**Item No. 9.1.1**  
**Design Review Committee**  
**April 11, 2019**

**SUBJECT:** Case 22222: Substantive Site Plan Approval – 1800 Argyle Street, Halifax

3 Enlarged East Elevation - Future Retail  
 1/4" = 1'-0"

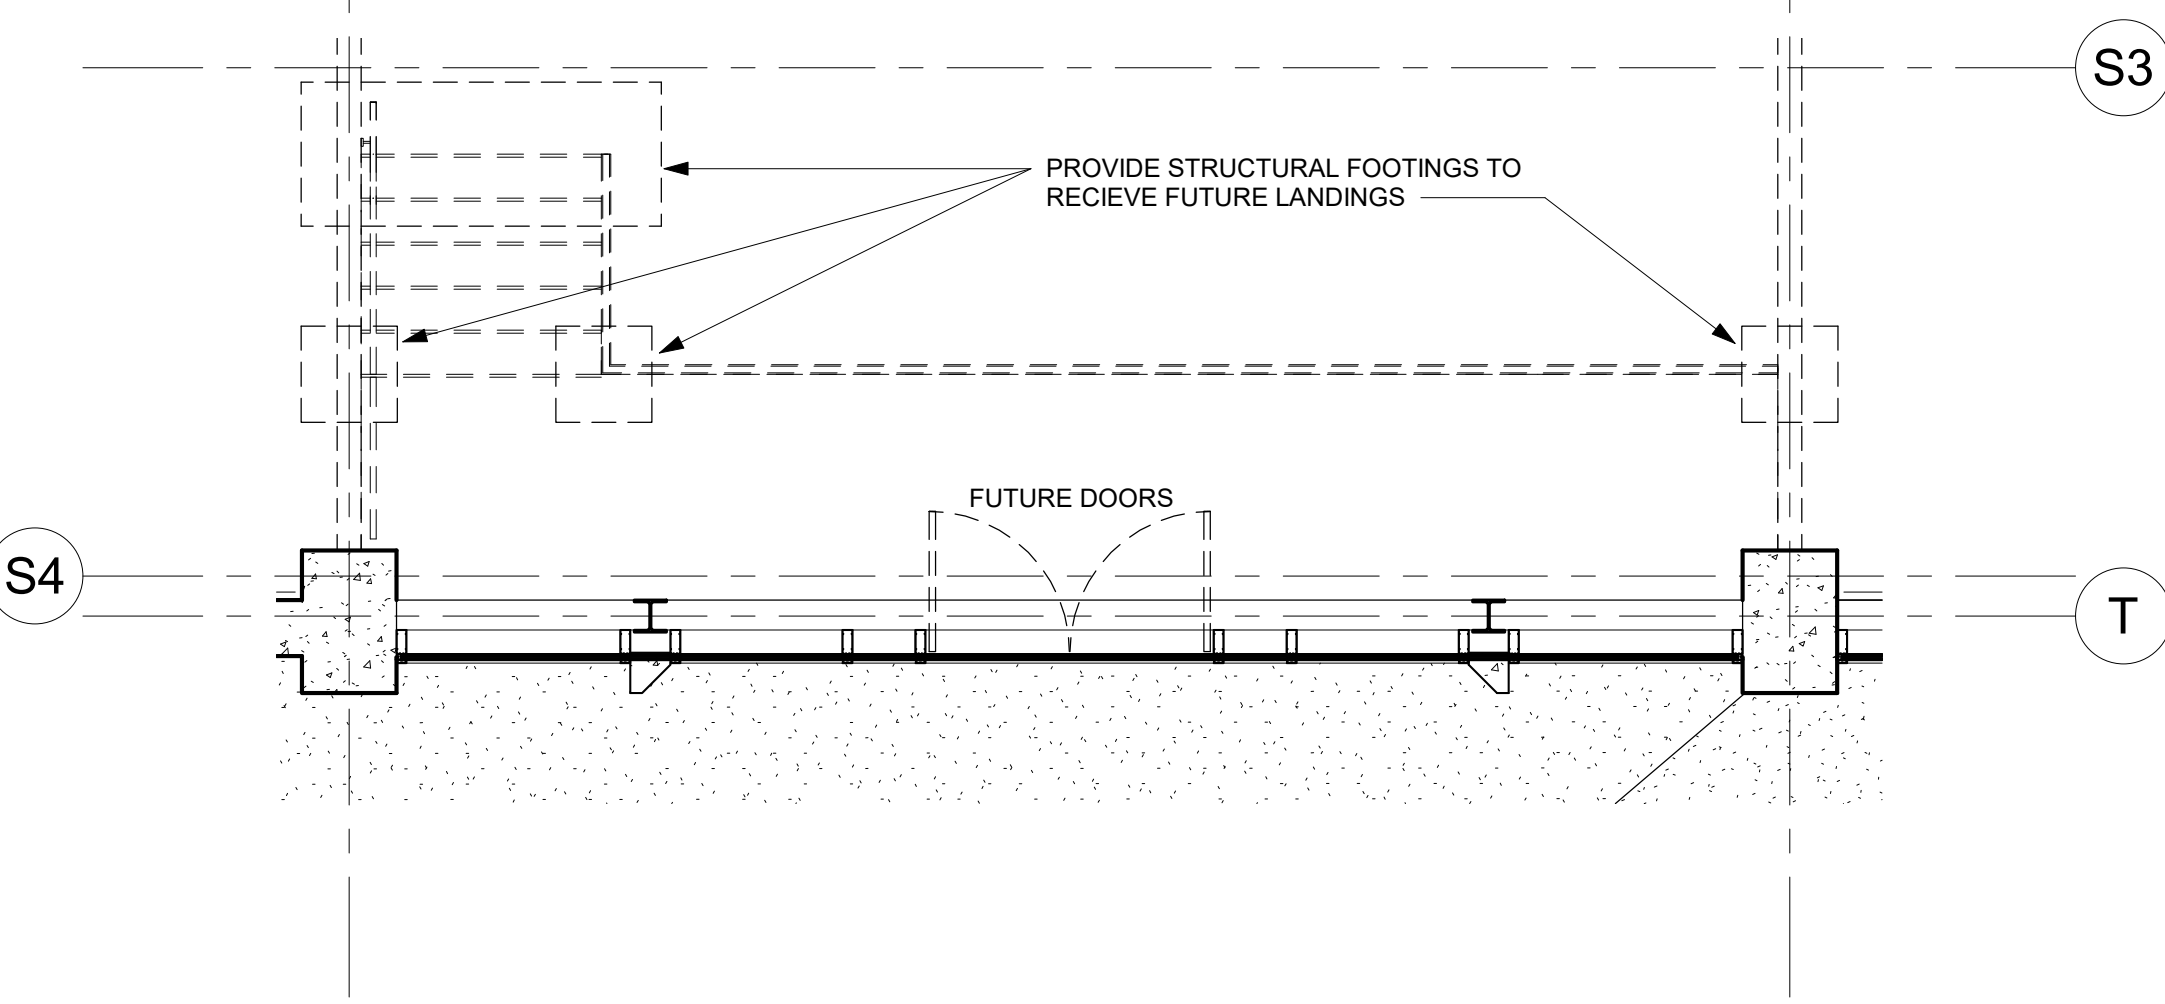
The initial design envisioned multiple new entries along Argyle St. Securing one individual tenant, for the Argyle Street level, necessitated a change in the number of entries. The curtain wall system will be designed in a way that the mullion spacing will allow for a glazed panel to be easily replaced with an entrance system in the future. Canopies will be constructed at the exterior, defining future shopfront entryways and giving the appearance of fine grained shopfronts in the midterm (see detail 3 on sheet A-203 Attachment A).

Appropriate footings will be built to receive future interior landings and steps to accommodate future at-grade entrances from the sidewalk, when needed. (See detail 4 on sheet A-203, Attachment A).
